Overview

The purpose of this notification is to communicate the addition of new shipping trays for the VO48/VOG48 TSOP packages.

Figure 1: Tray Details

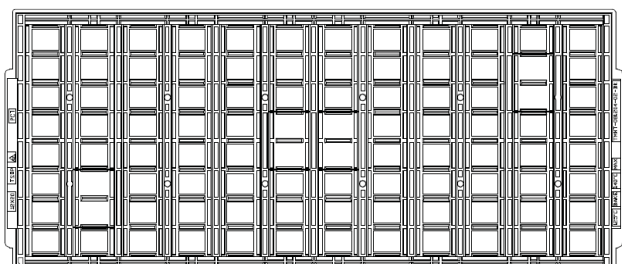
Xilinx is adding new shipping trays produced by PCT Technology for the VO48/VOG48 TSOP packages.

The new PCT Technology tray matrices are designed to be compatible with current Daewon shipping trays. The PCT Technology trays are stackable with Daewon trays, and will have the same X/Y tray dimensions as the Daewon trays.

Table 1 and Figure 1 provide further details of the PCT Technology shipping tray.

Tray 1: 124-1220-113B
Vendor: Daewon

Tray 2: TMHT-081204-02-B
Vendor: PCT Technology
